AMENDMENTS TO THE DRAWINGS

REMARKS/ARGUMENTS

Fig 1a

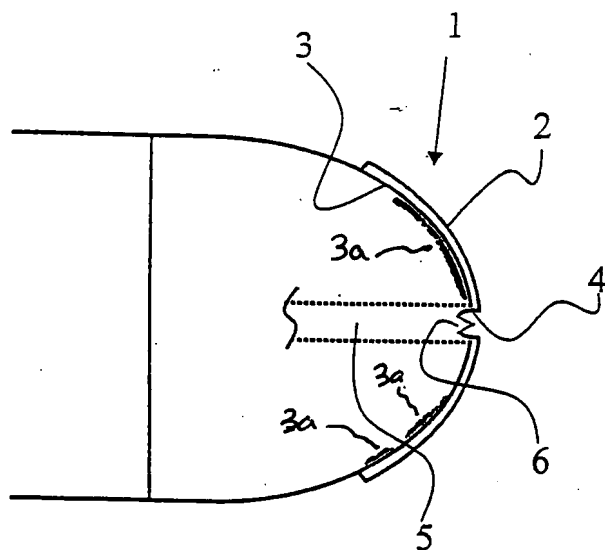
The attached sheets of drawings add glue 3a (and associated reference characters and lead lines) in Figure 1a.

Objections to the Drawings

The attached sheets of drawings add glue 3a (and associated reference characters and lead lines) in Figure 1a. Additionally, Applicant submits that Figure 1a shows inner side 3 formed as a substantially flat or weakly bending disk.
